# JACK LONDON DISTRICT 4TH & MADISON PROJECT

Response to Comments Document

Case No. ER15-005 State Clearinghouse No. 2015042051

Prepared for:
City of Oakland

TABLE IV.C-3 Intersection Operations Existing Conditions

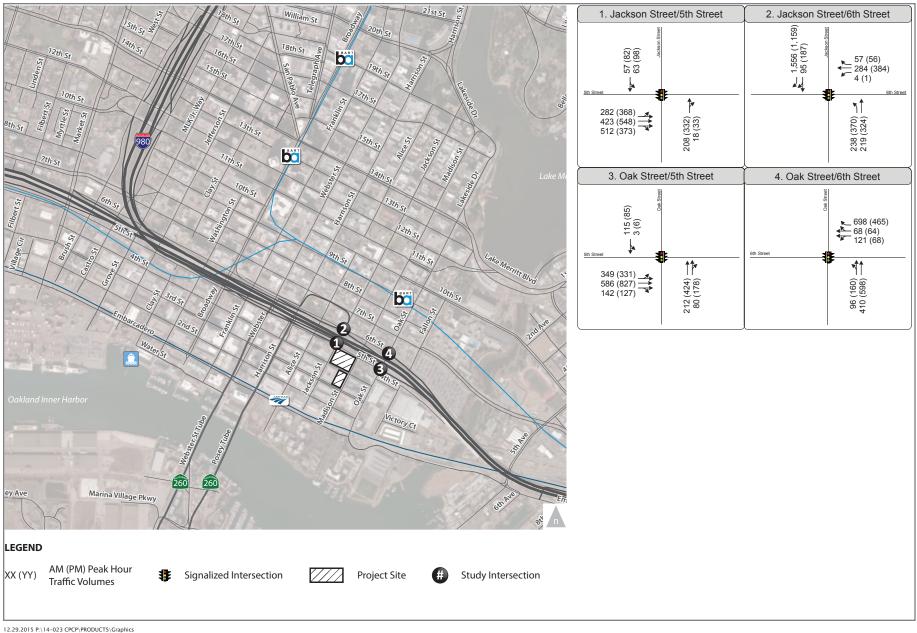
A1-2	Transportation Analysis Please clarify the Jackson Street/5th Street and Jackson Street/6th Street intersections' level of service (LOS) calculations between what is stated in Appendix D, Table 1, Intersection LOS Comparison, and Appendix C, Traffic and Transportation LOS Calculations. The 2035 + P PM results at the Jackson Street/5th Street and Jackson Street/6th Street intersections shows LOS C, but the calculations in Appendix C show LOS D for these same intersections.	Since publication of the Draft EIR, an updated traffic analysis using 2015 counts was completed and is provided in Appendix D Revised; the updated traffic counts are provided in Appendix C Revised (see Chapter IV of this RTC Document); Draft EIR Chapter IV.C Traffic and Transportation, is updated in its entirety in Chapter IV, Text Revisions, of this RTC document. Given that the revisions occur throughout the entire section, each of the individual revisions is not shown here. The complete revised section is provided in Chapter IV of this RTC for ease of seeing the revisions in the context of the complete section. Key excerpts of the text revisions are provided to updated information specific to the comment.

Table III-1 Response to Comments Matrix				
Comment # Comment	Response			
	Page 108, Intersection Operations subsection, is revised:			
	Intersection Operations  Table IV.C-3 summarizes the intersection LOS under Existing Conditions. As shown, three of the four study intersections currently operate at LOS B or better. The Jackson Street/6th Street intersection operates at LOS E during the AM peak hour and LOS D during the PM peak hour. The LOS calculations are included in Appendix C_Revised.			
	Page 130, subsection (1) Existing Plus Project Conditions, paragraph 3, is revised:			
	The intersection LOS results presented in Table IV.C-6 show that with the project (Existing Plus Project Conditions), all three of the four study intersections would continue to operate at LOS B or better during both AM and PM peak hours. The Jackson Street/6th Street intersection would operate at LOS E during both AM and PM Peak hours. All four study intersections are located within Downtown Oakland, where the LOS standard for intersection operations is LOS F. Therefore, the proposed project would not cause a significant impact at the study intersections under Existing Plus Project Conditions, and no mitigation measures are required.

Figure VI-4
Jack London District 4th & Madison Project EIR
Partial Preservation Alternative #2 Aerial View
REVISED FOR RTC

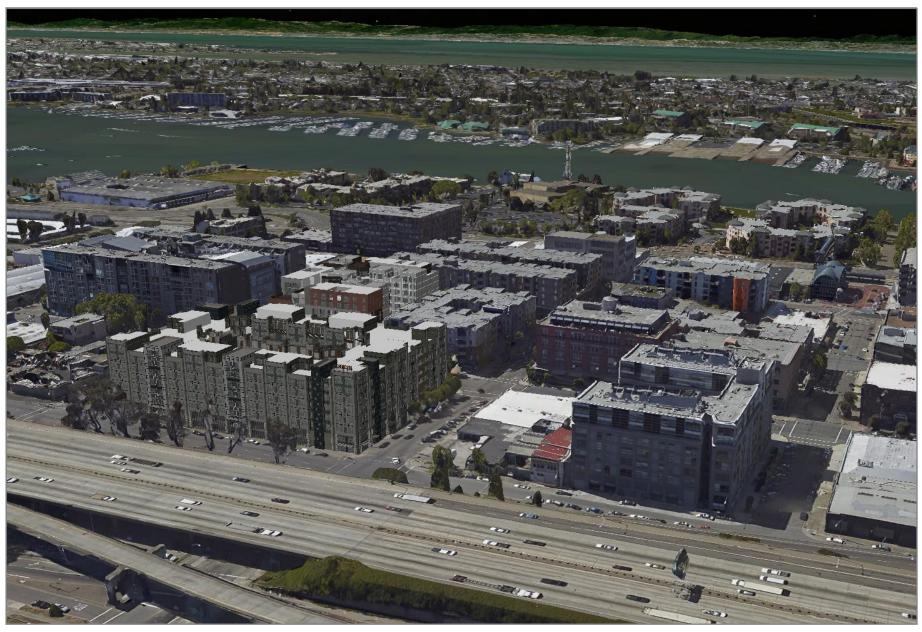
B7-5	In the revised alternatives analysis as well as in the main project studied, we request improved renderings showing historic district context. Please seriously analyze an alternative that carries out both the developer's program and the preservation of an important historic district.	Renderings of the proposed project and Partial Preservation Alternative #2 from additional vantage points in the context of the historic district are included as Figures VI-5 through VI-9, in Chapter 6, Alternatives, of the Draft EIR, as reflected in Chapter IV, Text Revisions. These figures were created to illustrate the existing district streetscape surrounding the project site in response to public and LPAB comments requesting analysis of the two within the context of the District and surrounding area. See response to comment B3-1 for further detail on this process. As described on page 83 of the Draft EIR, and in the text revisions to page 85 of the Draft EIR shown in response to comment B4-19, the proposed project would not in and of itself materially alter the District's integrity or eligibility for the National Register. Furthermore, as described throughout Chapter VI, Alternatives, of the Draft EIR, all alternatives would preserve the historic district in regard to project-level impacts.

# Pages 279 through 281 are revised, including new figures VI-6 through VI-9 added:

Figure VI-9

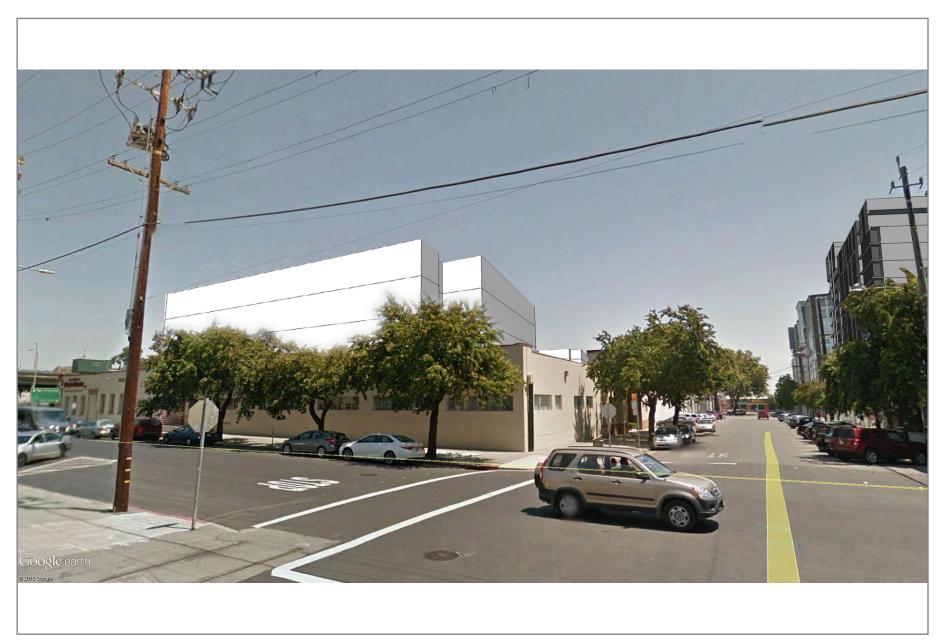
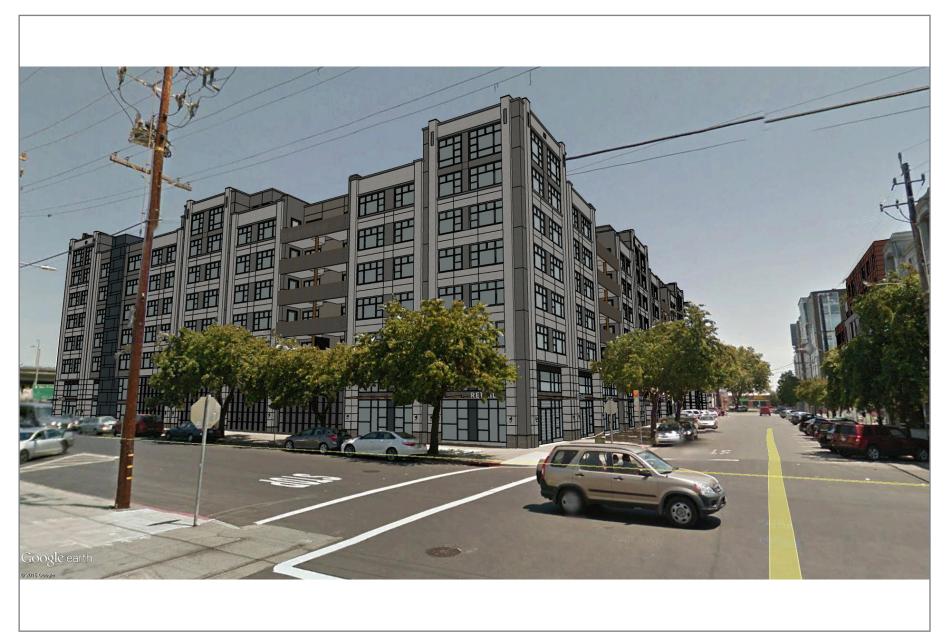
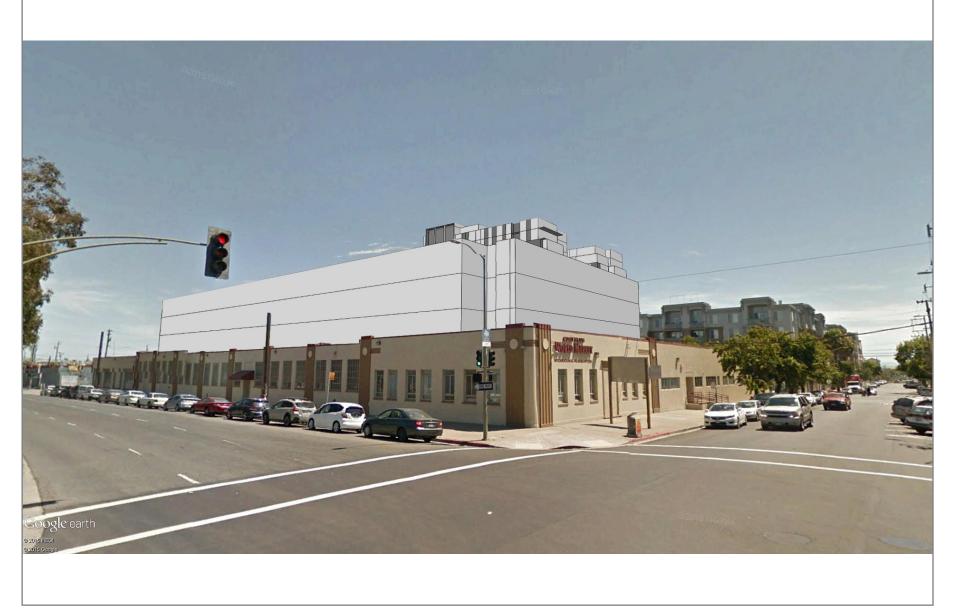
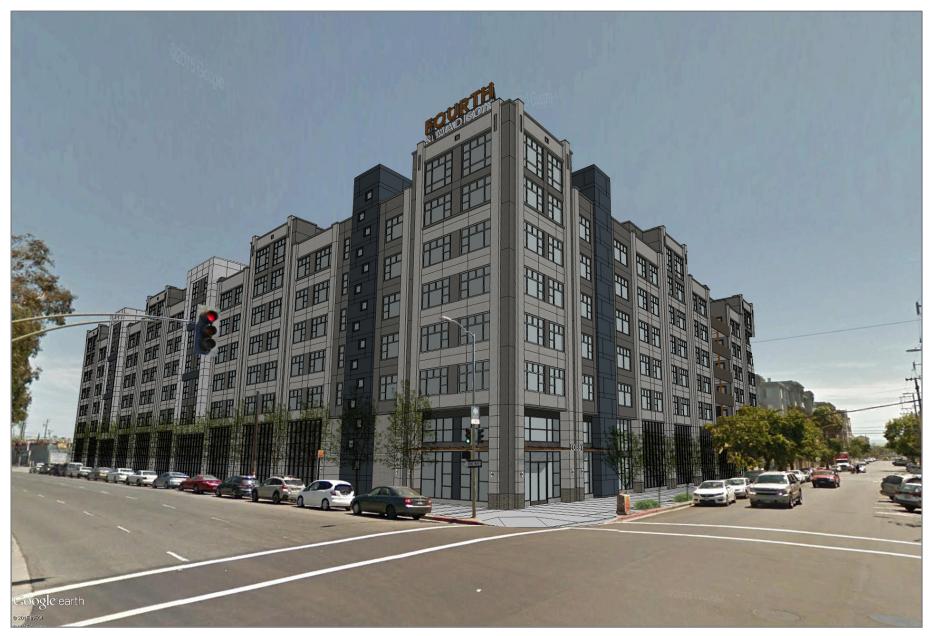
Need clarification of how façade money is developed.	See responses to comments B1-2, B1-3, B2-6, B3-12, and B4-25.
	<ul> <li>Elevations and rendered drawings should show the building within the District.</li> </ul>	See response to comment B3-1, and Figures VI-5, VI-7, and VI-9 in Chapter 6, Alternatives, of the Draft EIR, and as reflected in Chapter IV, Text Revisions of the Response to Comments document.
	Agree we should bring more housing into City.	This comment does not specifically address the adequacy of the EIR. It has been noted, but no further response is necessary.
D4 Chris	stopher Andrews	
	Is one of the issues with preservation that the façade worth saving is mid-block or not in an ideal location for proposed project?	Two preservation alternatives were presented in the DEIR for the proposed project. See Partial Preservation Alternative #1 and Partial Preservation Alternative #2 for a discussion of these two alternatives. Moreover, a new mitigation measure has been added to the EIR, Mitigation Measure HIST-1e, which would require the project sponsor to salvage at least two of the pilasters from the existing building façade and incorporate them into the proposed building design. See response to comment B1-8.
